northern beaches council  
**THIS PLAN IS TO BE READ IN CONJUNCTION WITH THE CONDITIONS OF DEVELOPMENT CONSENT**  
 MOD2023/0526

SEC 4.55 Retail/Business Glazing Amended:

SECTION 4.55 APPLICATION

Ground Parking / Retail  
 SCALE 1:100 @ A3

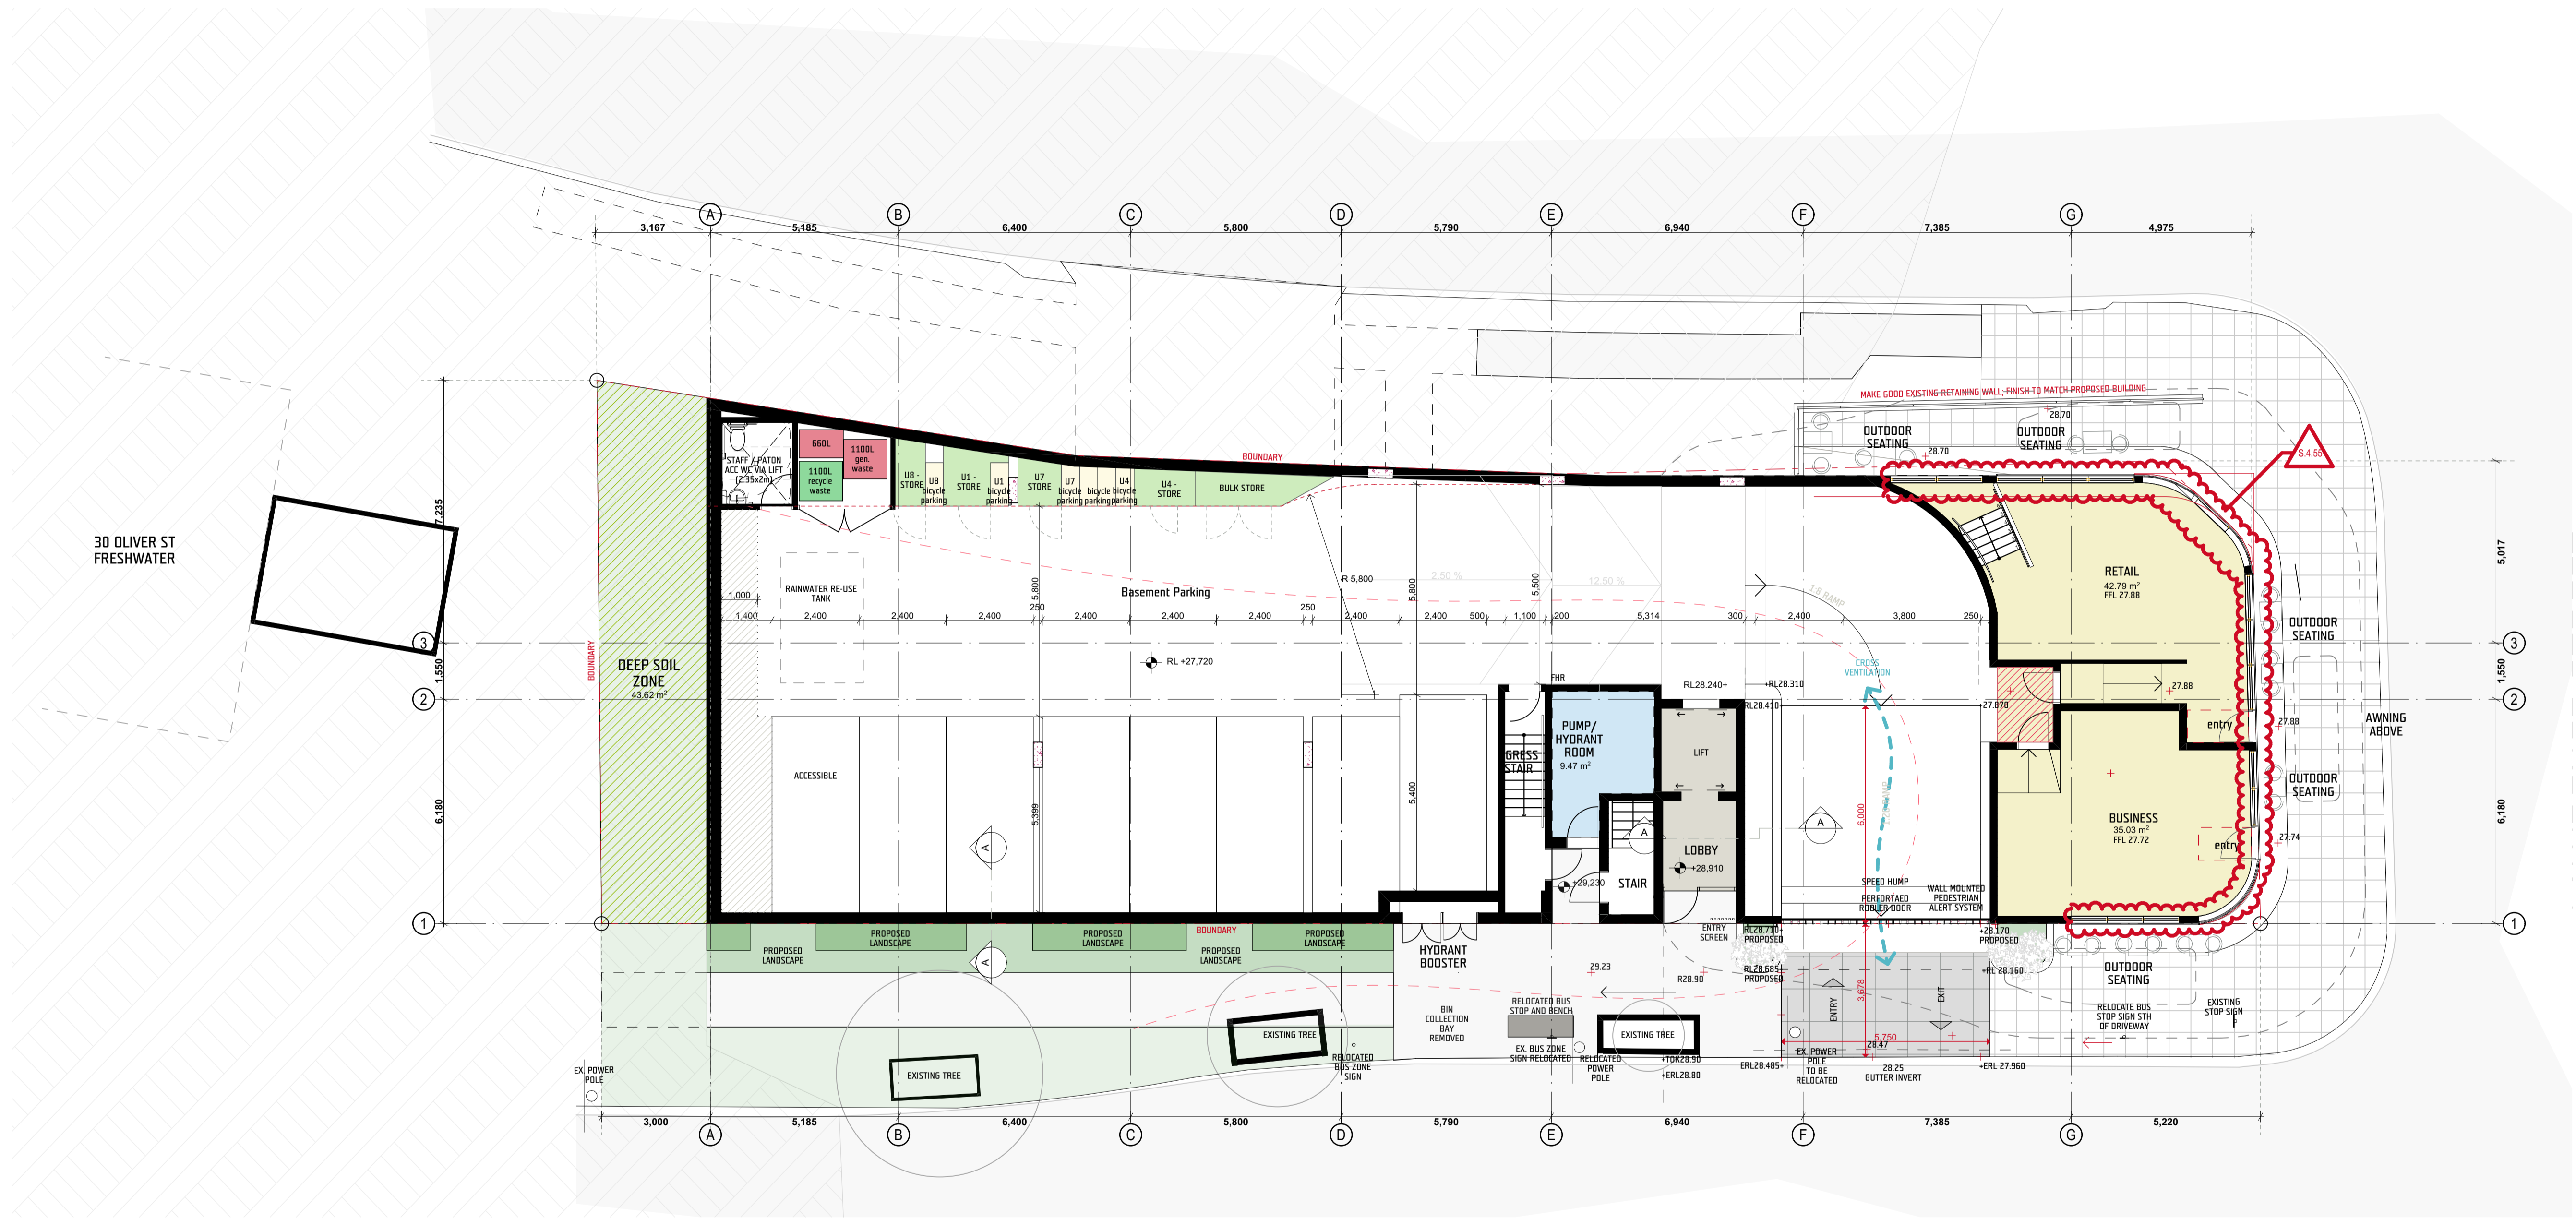
- Additional 150mm to plinth height on the eastern return
- Please see DA-2001/2 for further amendments

1 EAST ELEVATION  
SCALE 1:100 @ A1

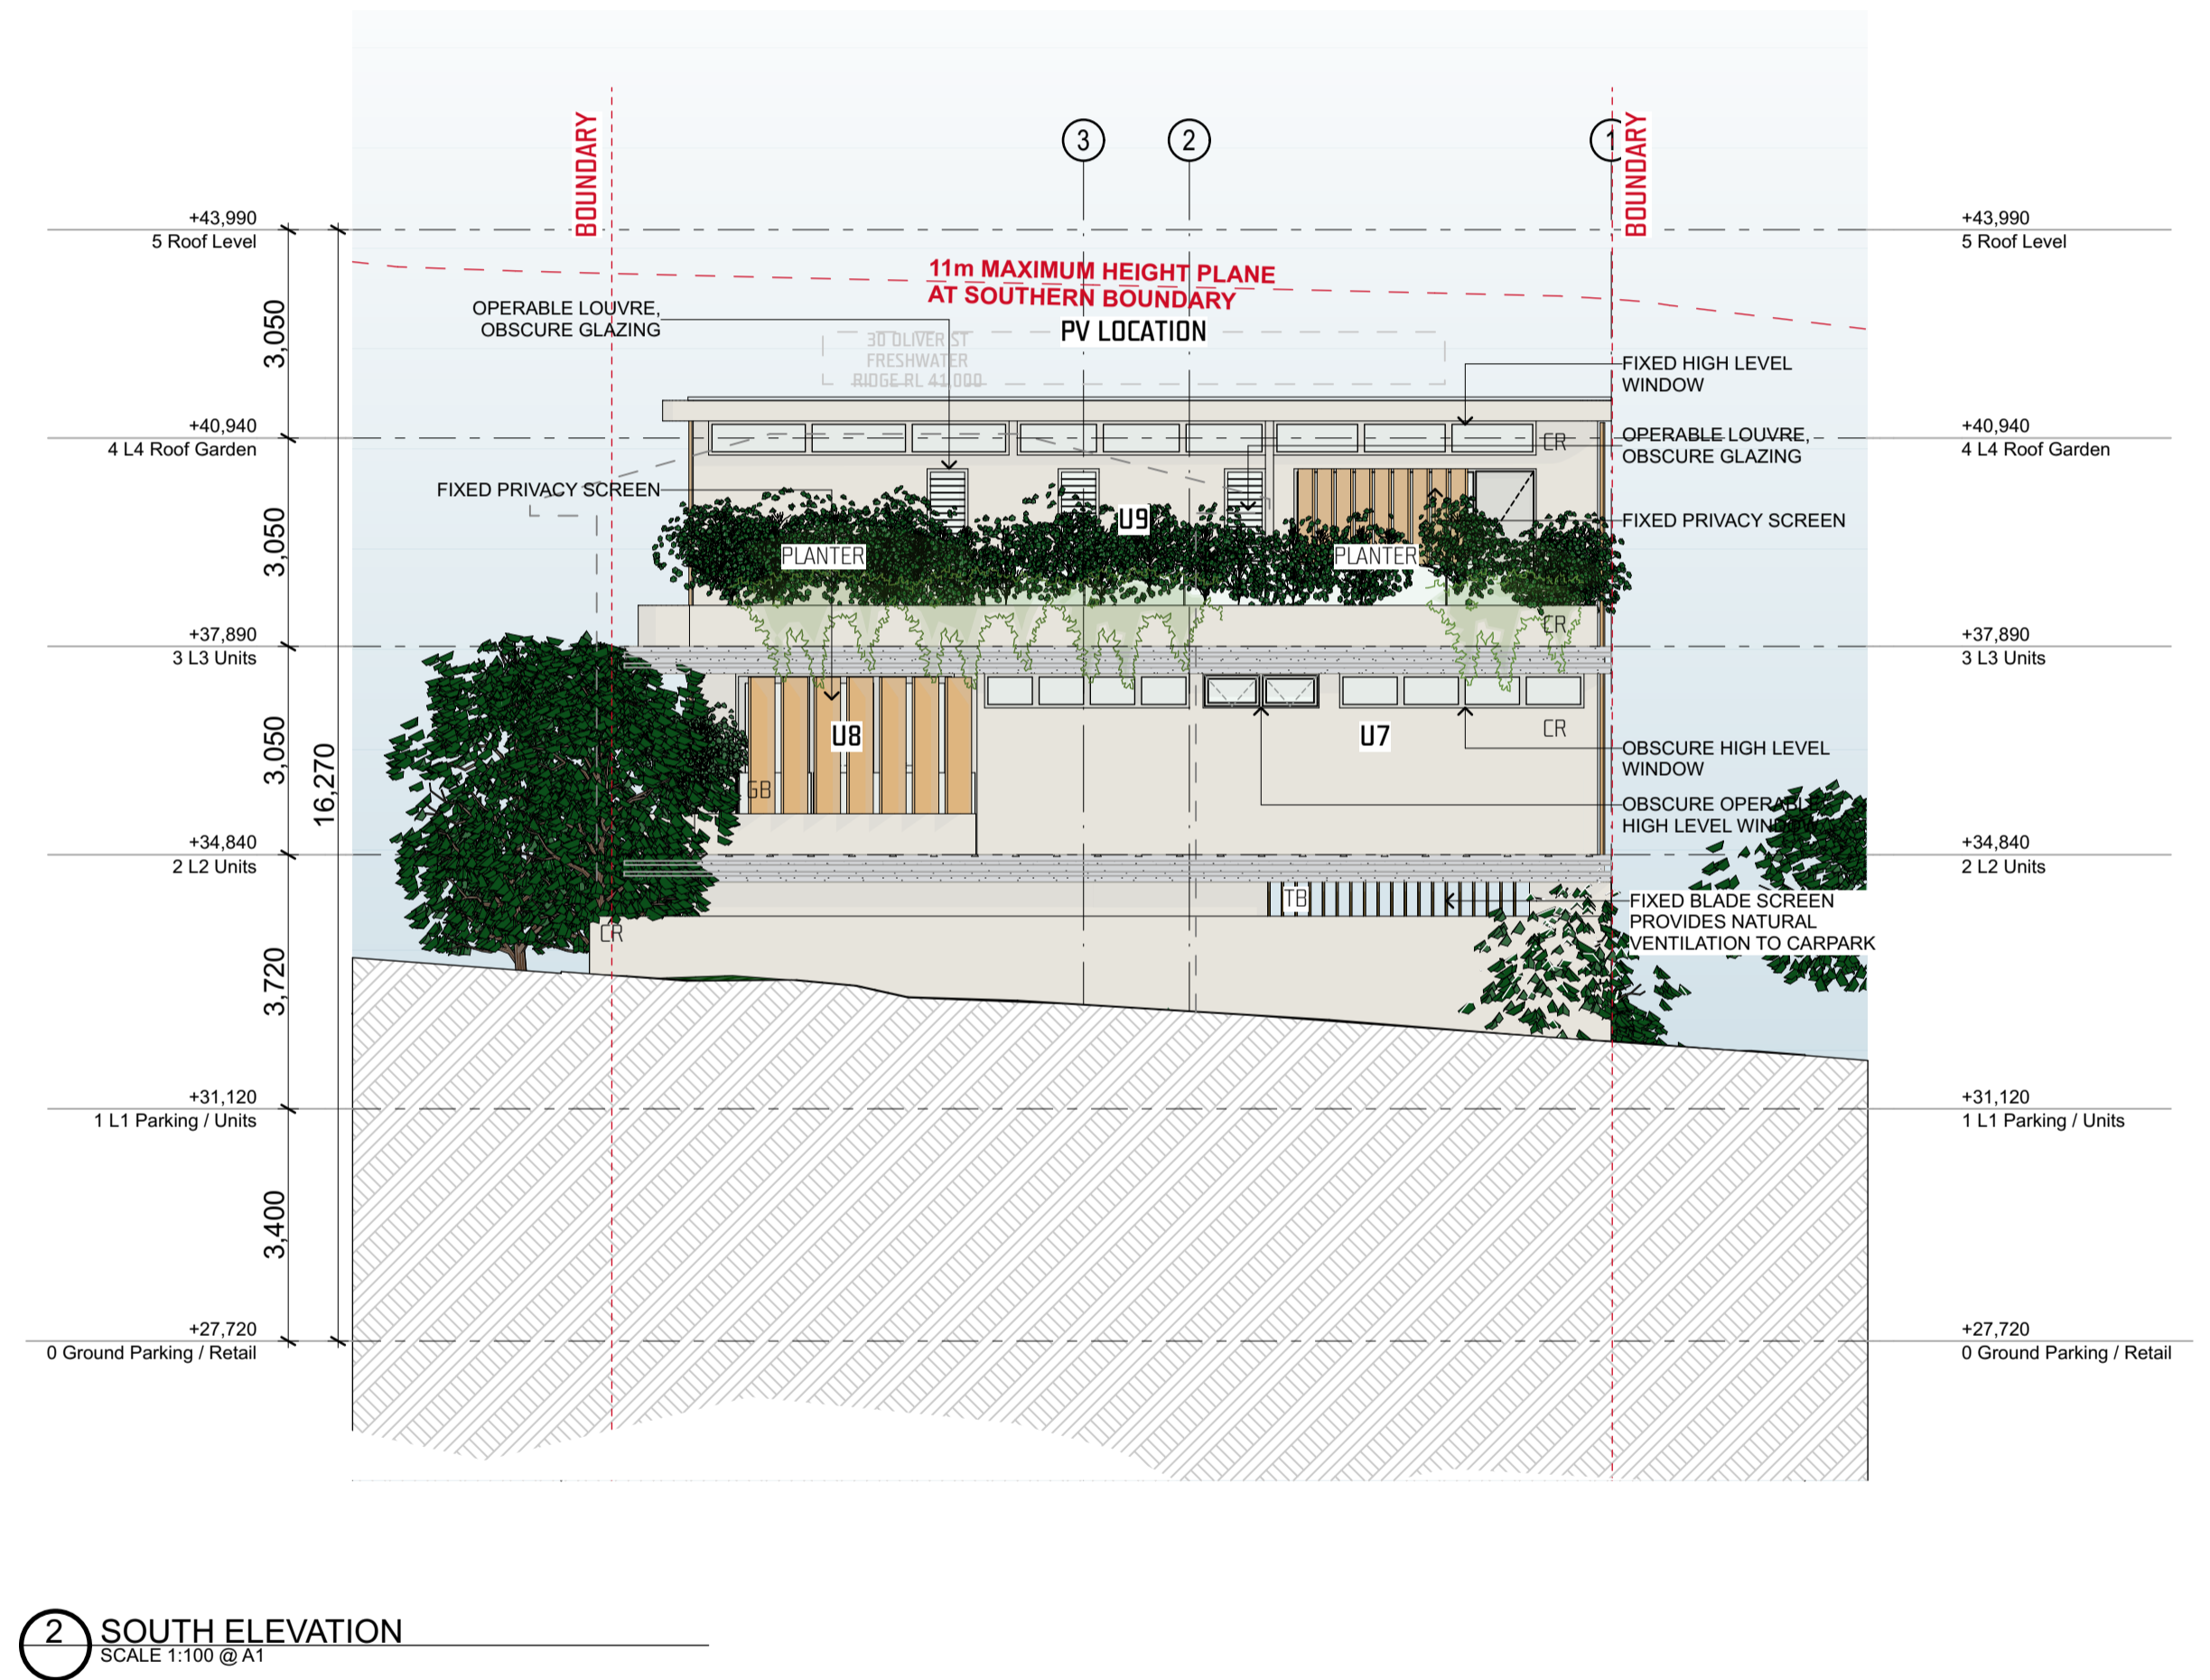
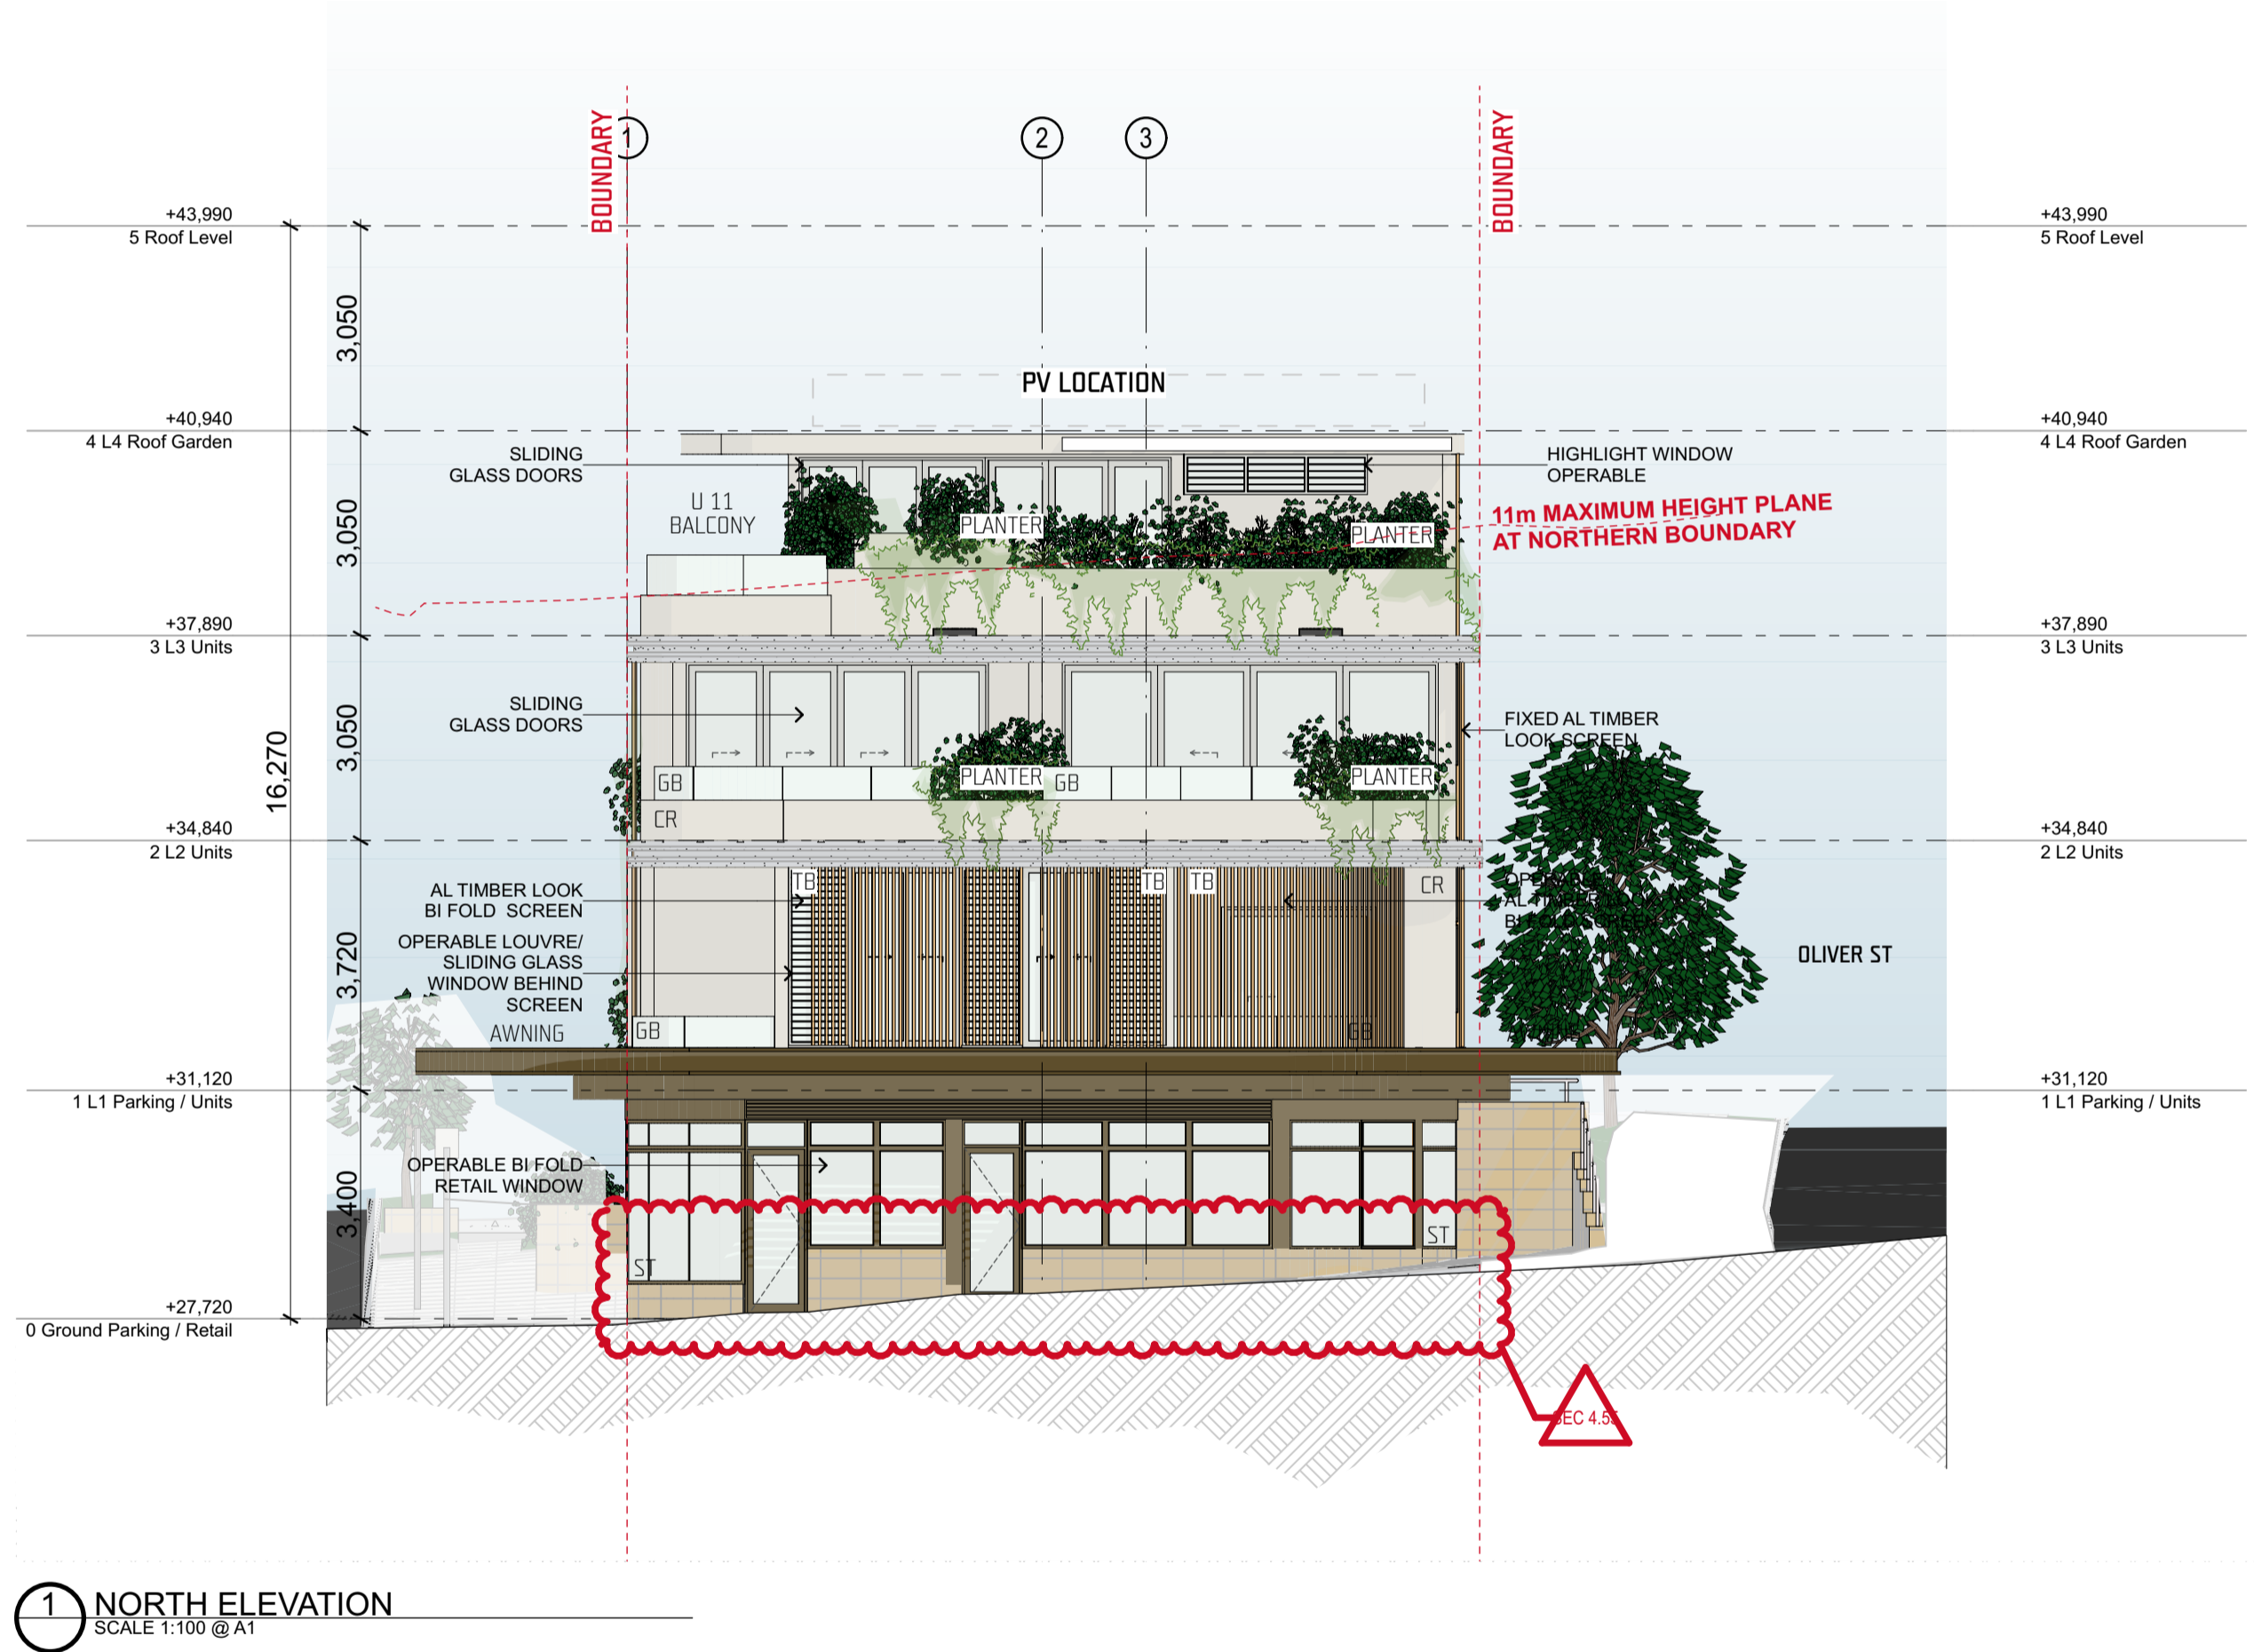
SEC 4.55 Retail/Business Glazing Amended:

- Additional 150mm to plinth height on the Eastern return of the business tenancy
- Glazing plinth height raised to business tenancy north

SEC 4.55 Retail/Business Glazing Amended:

- Additional 150mm to plinth height on the Eastern return of the business tenancy
- Western face glazing matches plinth height for front/north windows of retail/business tenancy
